2021 Edition – Supplemental Standard Specifications Effective with February 2021 Lettings

Make the following revisions to the standard specifications:

The following drawings shall be replaced with revised details as named:

URBAN DRIVEWAY

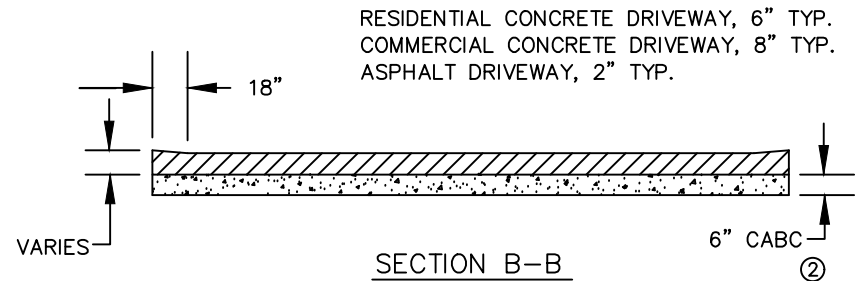
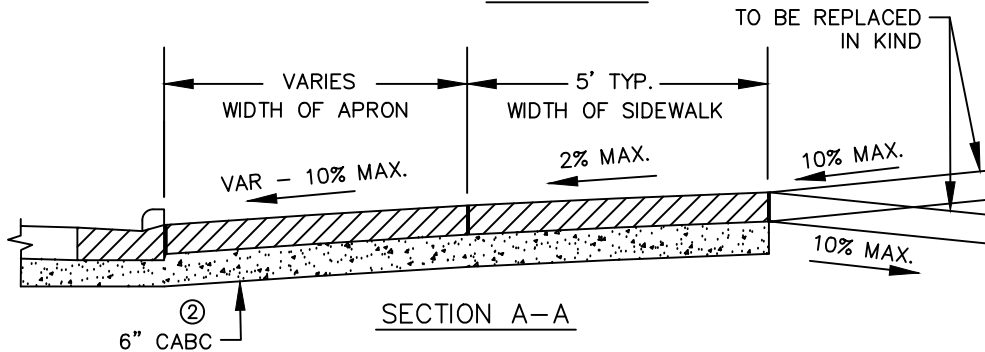
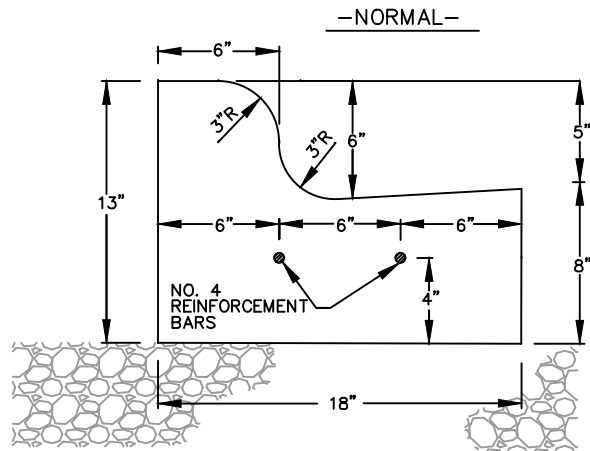
- Urban Driveway
- Curb and Gutter Sections – 18”
- Curb and Gutter Sections – 24”
- Curb and Gutter Sections – 30”
- Sidewalk & Curb Ramp Construction
- Sidewalk & Curb Ramp Construction (Continued)
